Land-Rover Service Newsletter Vol.3 No.20

January 1971

The Rover Company Limited Service Department, Solihull, Warwickshire, England

Fig. 1 Correct position of steering rod clip

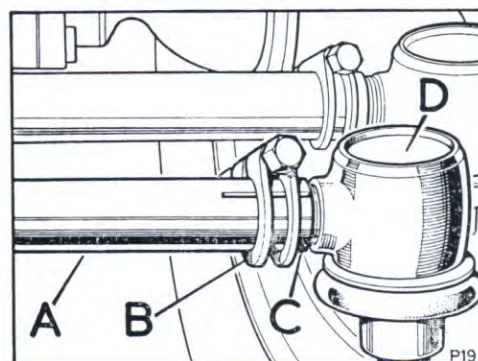
Item 128 SUBJECT: **STEERING ROD CLIPS AND BALL JOINTS**
 MODELS: Land-Rover, all models.
 REMARKS: Further to the information circulated by means of Land-Rover News Letter Vol. 3 No. 18, item 214, it is important that the steering ball joints are thoroughly inspected at the recommended 6.000 km (4,000 miles) intervals.
 Ensure that there is no undue wear, and that the rubber boot is not dislodged or damaged.
 The check should be extended to ascertain the effectiveness of the steering rod clips, especially when vehicles are operating under extremely arduous conditions. Early type clips, Part No. 552038, which show evidence of distortion, should be replaced by the modified type, Part No. 577898.
 The correct position of the clip is shown at Fig. 1.
 The relevant tightening torques are as follows:
 Ball joint fixing nut: 4 mkg (30 lb ft).
 Clamp retaining nut: 1,4 mkg (10 lb ft).

It should be noted that the highest clamping effect, in particular on linkages with one slot only, is achieved with the open section of the clip situated over the slot.
